Proposal for amendments to false reaction avoidance of UN Regulation 152

I. Proposal

Figure 1: LEFT TURN OR RIGHT TURN AT THE INTERSECTION

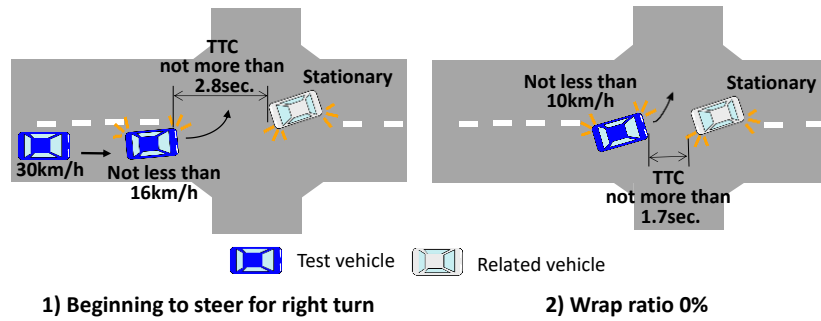
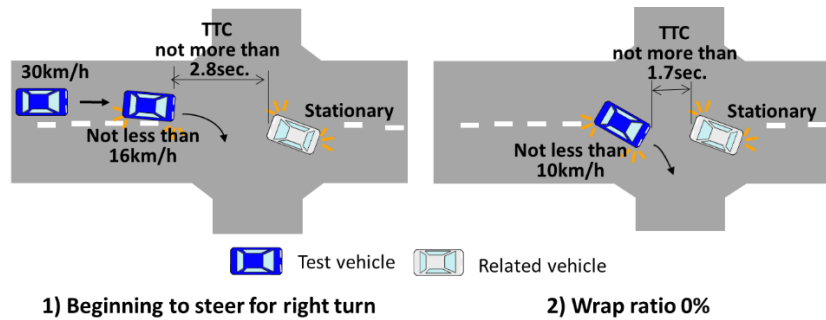
Scenario 1: Left turn or Right turn at the intersection

1.1. In this scenario, the subject vehicle passes by a left turn or right turn in front of an oncoming vehicle that is stopped to make a left turn or right turn at an intersection.

The subject vehicle drives at a speed of 30 km/h (with a tolerance of +0/-2 km/h) toward the intersection, and decelerates by braking to a speed of not less than 16 km/h at a point where the subject vehicle begins to steer left / right, and the TTC to the oncoming vehicle is not more than 2.8 seconds. When the subject vehicle turns left or right in the intersection, the speed is reduced to not less than 10 km/h, and then drives at a constant speed. The TTC to the oncoming vehicle is not more than 1.7 seconds at when the wrap ratio between the subject vehicle and the oncoming vehicle becomes 0%.

Figure 2: RIGHT TURN OR LEFT TURN OF A FORWARD VEHICLE

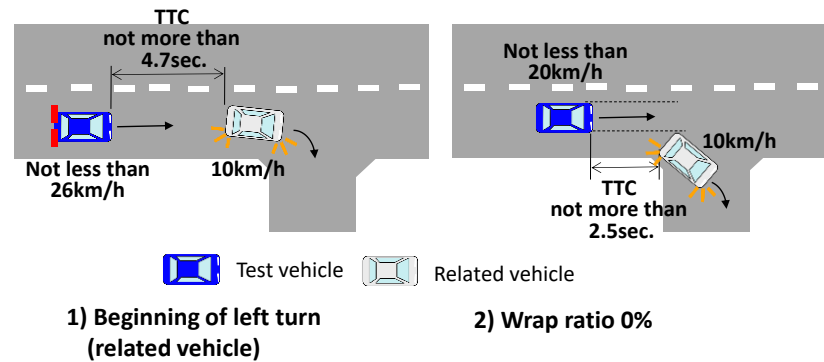
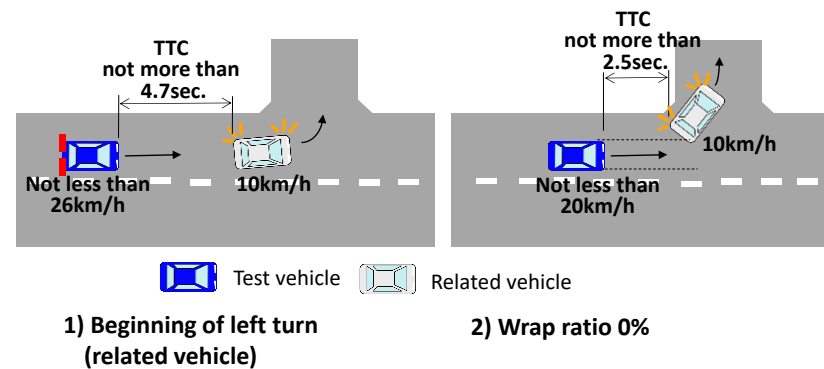
Scenario 2: Right turn or Left turn of a forward vehicle

2.1. In this scenario, the subject vehicle follows a forward vehicle. After that, the forward vehicle turns right or left at a corner, and the subject vehicle goes straight.

Both the forward vehicle and the subject vehicle drive at a speed of 40 km/h (with a tolerance of +0/-2 km/h) on the straight road. The forward vehicle decelerates by braking to a speed of 10 km/h (with a tolerance of +0/-2 km/h) in order to turn right or left at the corner, and the subject vehicle also decelerates by braking to keep appropriate distance with the forward vehicle. At when the forward vehicle begins to turn right or left, the speed of the subject vehicle is not less than 26 km/h and the TTC to the frontal vehicle is not more than 4.7 seconds. After that, the subject vehicle decelerates to a speed of not less than 20 km/h, and then drives at a constant speed. The TTC to the forward vehicle is not more than 2.5 seconds at when the wrap ratio between the subject vehicle and the forward vehicle becomes 0%.

Figure 3: CURVED ROAD WITH GUARD PIPES AND A STATIONARY OBJECT

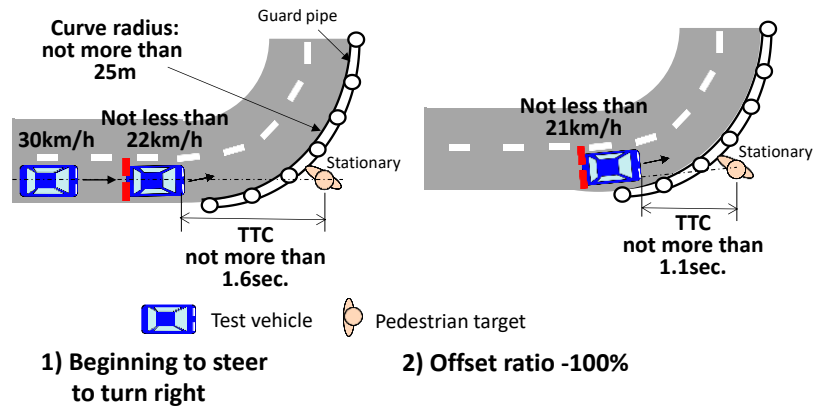
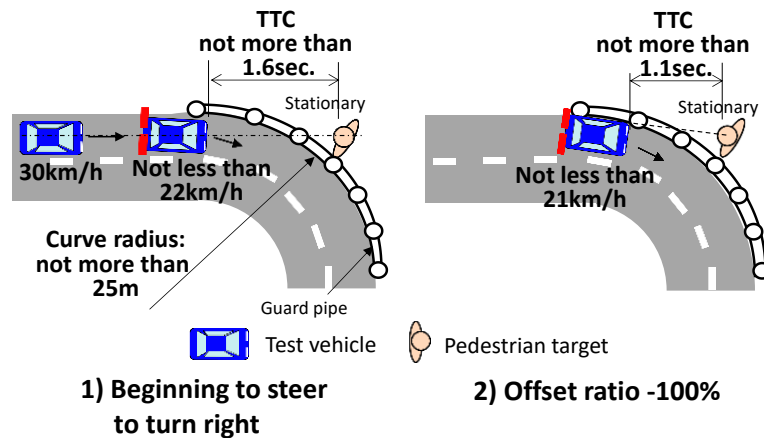
Scenario 3: Curved road with guard pipes and a stationary object

- 3.1. In this scenario, the subject vehicle drives a small radius curved road of which the guard pipes are constructed to the outer side, and a stationary vehicle (M1 category), a stationary pedestrian target or a stationary bicycle target is positioned just outside of the guard pipes and where on the extension of the centre of the lane.
- 3.2. An example of the detail scenario:

The subject vehicle drives at a speed of 30 (with a tolerance of +0/-2 km/h) km/h toward the curve of which the radius is not more than 25 m at the outer side of the road, and decelerates by braking to a speed of not less than 22 km/h at a point where the subject vehicle enters the curve. The TTC to the stationary object is not more than 1.6 seconds at when the subject vehicle begins to turn in the curve. In the curve, the subject vehicle drives outer lane than the centre of the road. After that, the subject vehicle continue to turn in the curve at a constant speed of not less than 21 km/h. The TTC to the stationary object is not more than 1.1 second at when the wrap ratio between the subject vehicle and the stationary vehicle becomes 0%, or at when the offset ratio* between the subject vehicle and the centre of the stationary pedestrian target or the stationary bicycle target becomes -100%.

Figure 4: LANE CHANGE DUE TO ROAD CONSTRUCTION

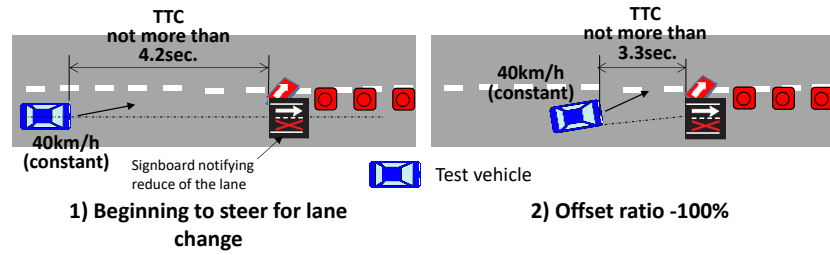
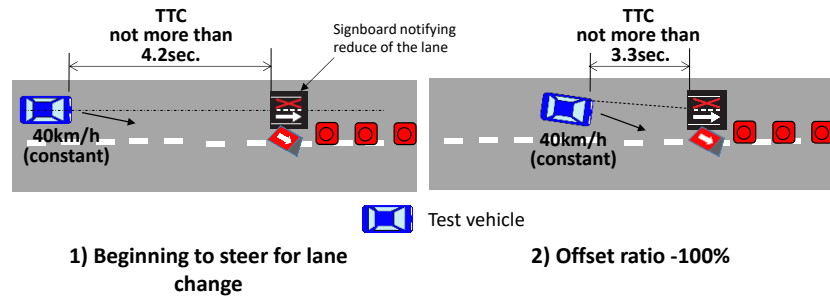
Scenario 4: Lane change due to road construction

4.1. In this scenario, the subject vehicle changes the lane in front of the signboard which is positioned in the centre of the lane and notifies the driver that the lane is reduced.

The subject vehicle drives a straight road at a speed of 40 km/h (with a tolerance of +0/-2 km/h), and begins to steer in order to change the lane in front of the signboard which notifies reducing the lane. No other vehicles approach the subject vehicle. The TTC to the signboard is not more than 4.2 seconds at when the subject vehicle begins to steer. During changing the lane, the speed of the subject vehicle is constant, and the TTC to the signboard is not more than 3.3 seconds at when the offset ratio between the subject vehicle and the centre of the signboard becomes -100%.
